THALIA (801)

Excessive hum in phono when Thalia is placed on top of a power amplifier.

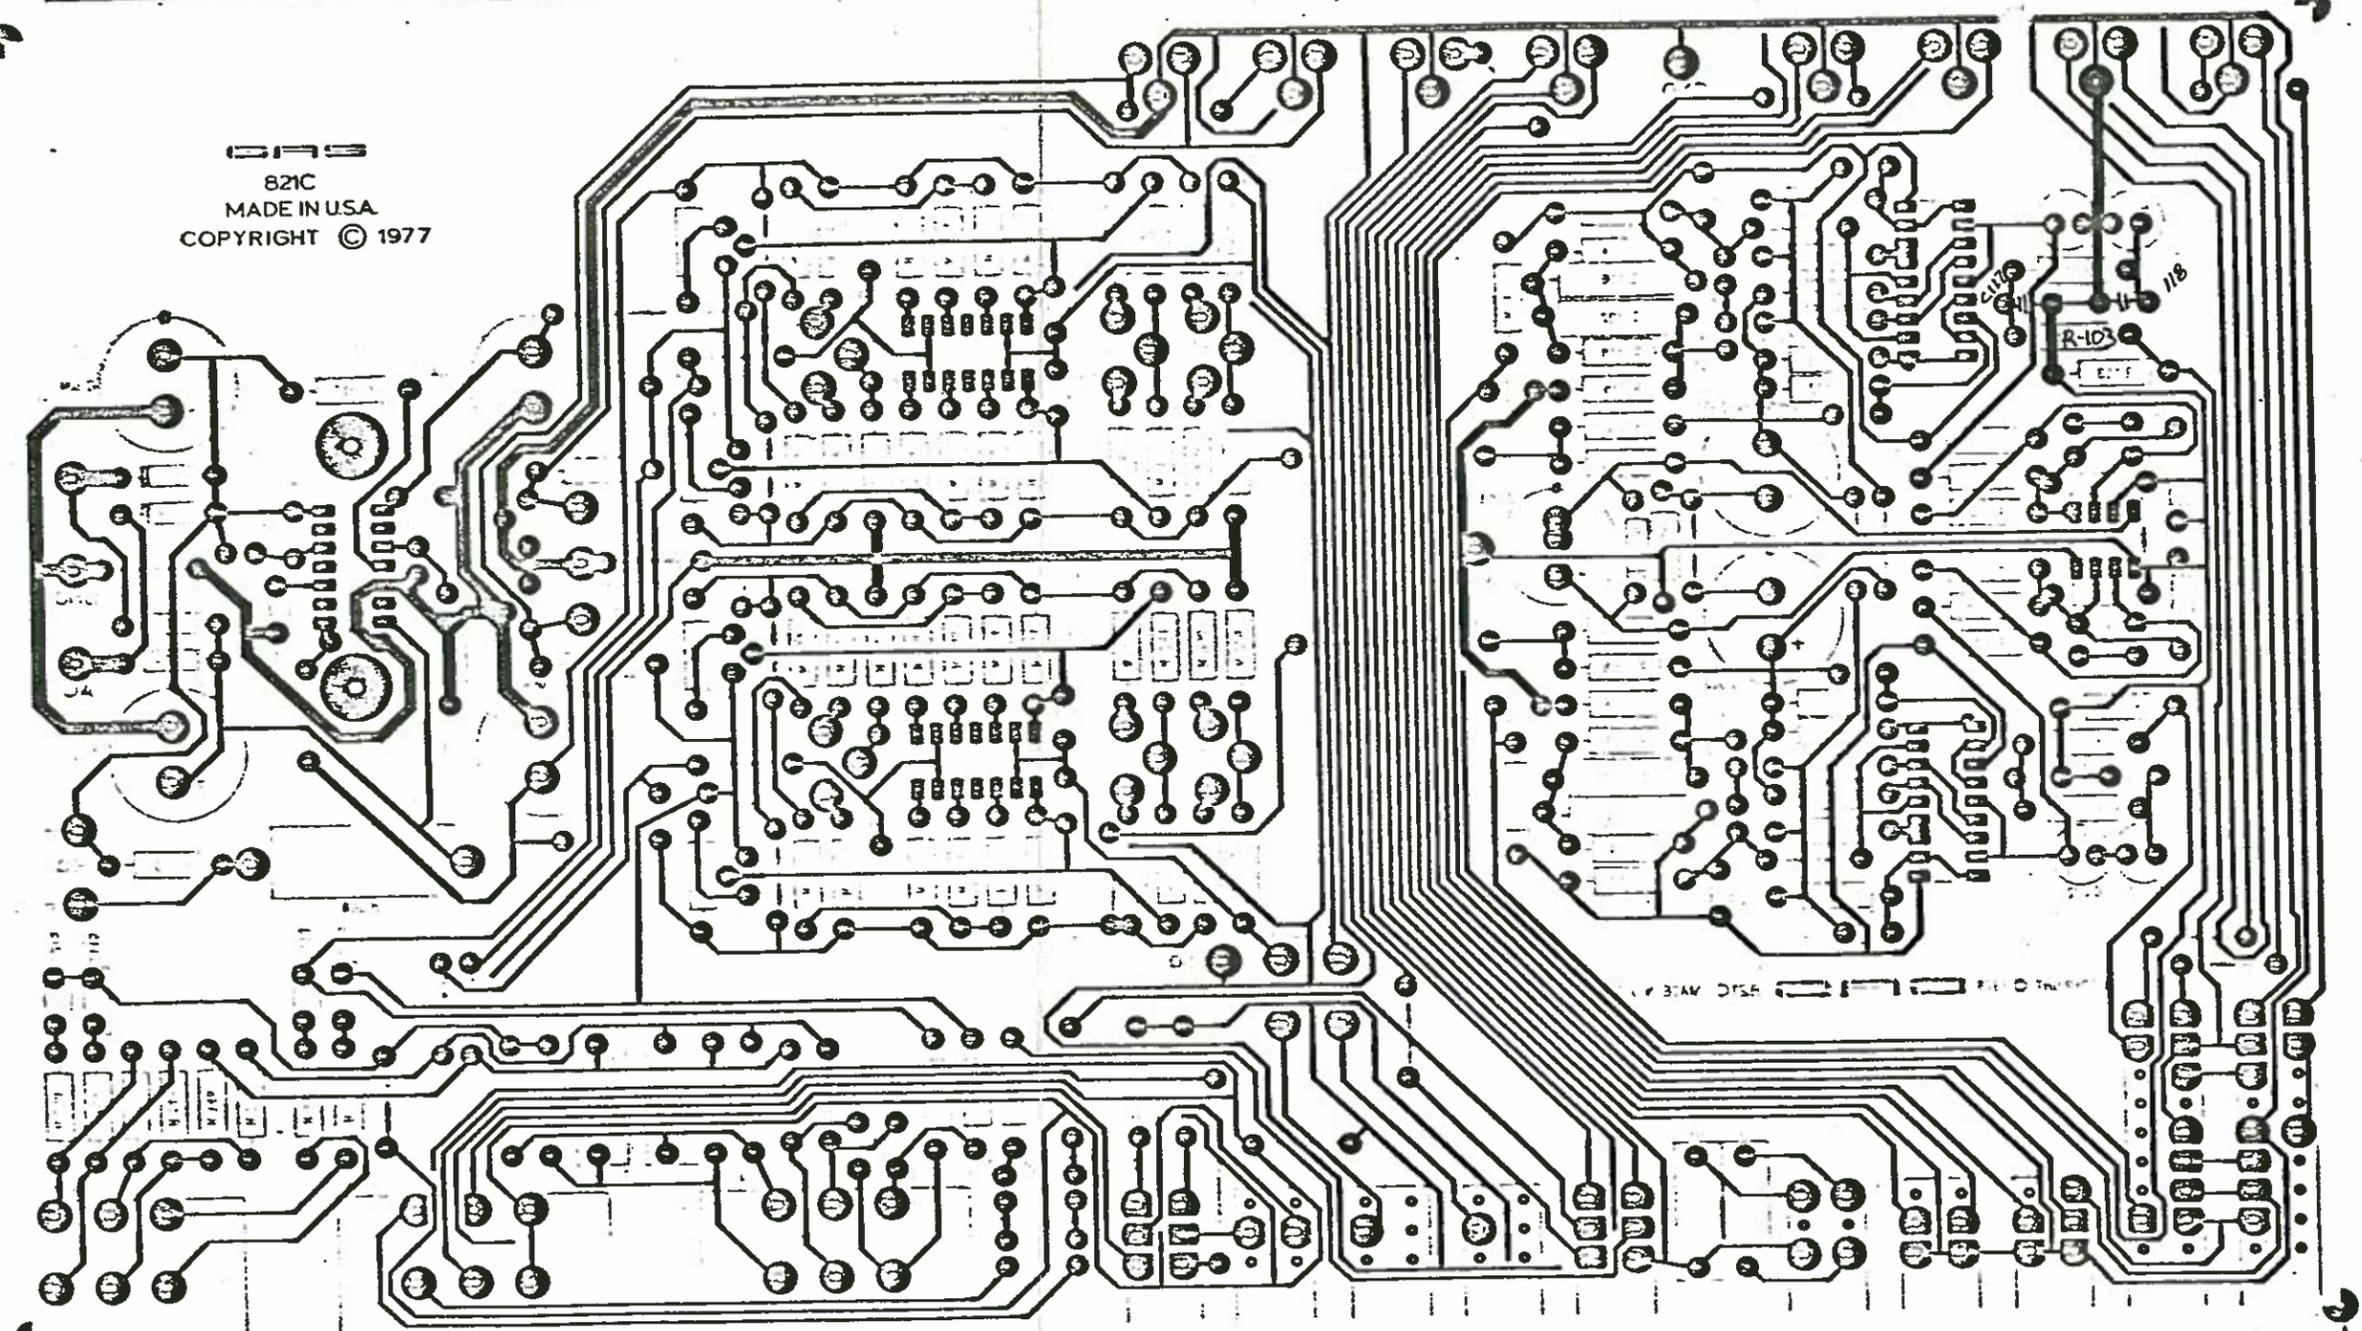
Ground loop in phono circuitry.

Modify ground traces on phono section.

1. Remove bottom cover.
2. Refer to the pictorial for location of repair area.
3. Cut ground foil, between phono II and tuner at (Point No. #1).
4. Add jumper 1.125" between the ground of phono II at (Point No. #2), and the ground of C117 and C118 at (Point No. #3).
5. Add 0.5" jumper between (Point No. #4) and ground R103 at (Point No. #5).
6. Replace the bottom cover.
7. Turn on unit, check for proper operation.

CUT
FOIL
HERE →
